Technical Service Bulletin

19J1 UPDATE – 4.0 I Quality Package (NVLW)

November 13, 2013

Model(s)	Year	VIN Range	Vehicle-Specific Equipment
S6, S7, A8, and S8	2013 - 2014	See Campaign/Action screen in ElsaWeb	None

Figure 1. Coolant thermostat (2).

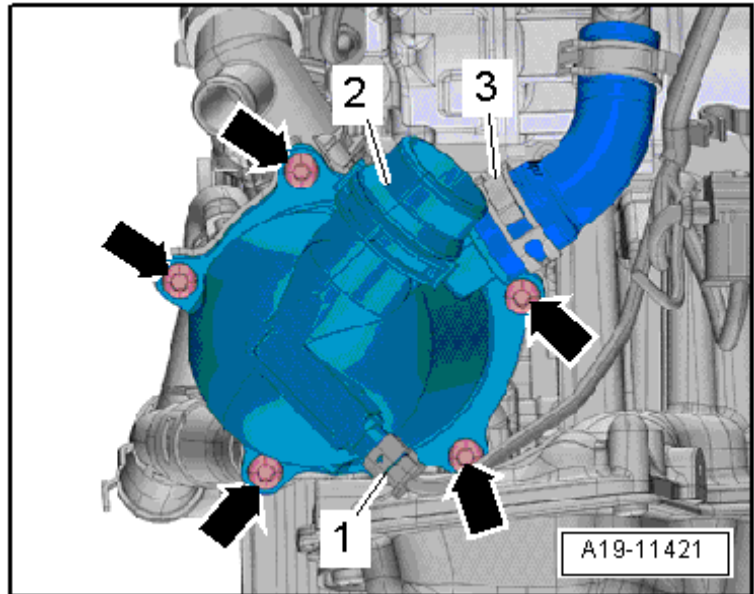
1. Replace the coolant thermostat and the quick release coupling by following the instructions in *ElsaWeb >> Repair Manual >> Engine >> Engine Mechanical >> 19 Cooling System >> Removal and Installation >> Map Controlled Engine Cooling Thermostat -F265-* (Figure 1 and Figure 2).

Figure 2. Quick release coupling (1).

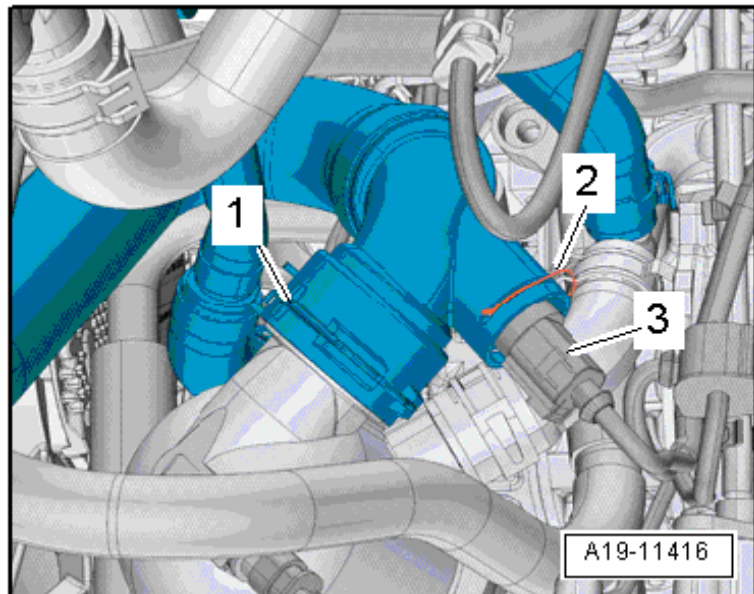
Tip: The quick release coupling is located directly on the coolant thermostat. It is removed together with the coolant thermostat when the coolant thermostat is replaced. However, the coolant thermostat does not have to be removed when the quick release coupling is replaced (Figure 1 and Figure 2).

Figure 3. Closure plate for bumper cover (3).

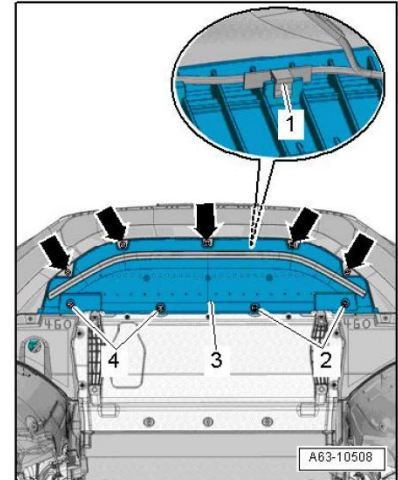
1. Remove closure plate for bumper cover (Figure 3)

Figure 4. Fit protective grille onto radiator.

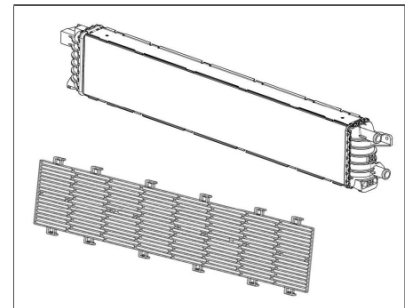
2. Fit protective grille onto radiator (Figure 4) and secure with nine retaining clips (Figure 5).

Figure 6. Location of ACF hose (A).

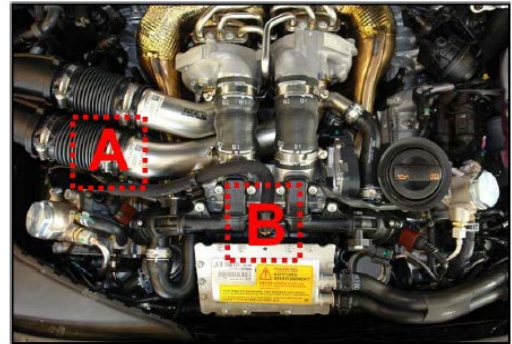
1. Replace ACF hose (Figure 6 and Figure 7). The hose clip can be re-used.

Figure 8. Hose clip (3).

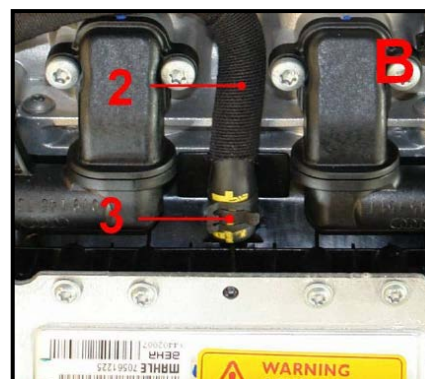
2. Replace hose clip (Figure 8).
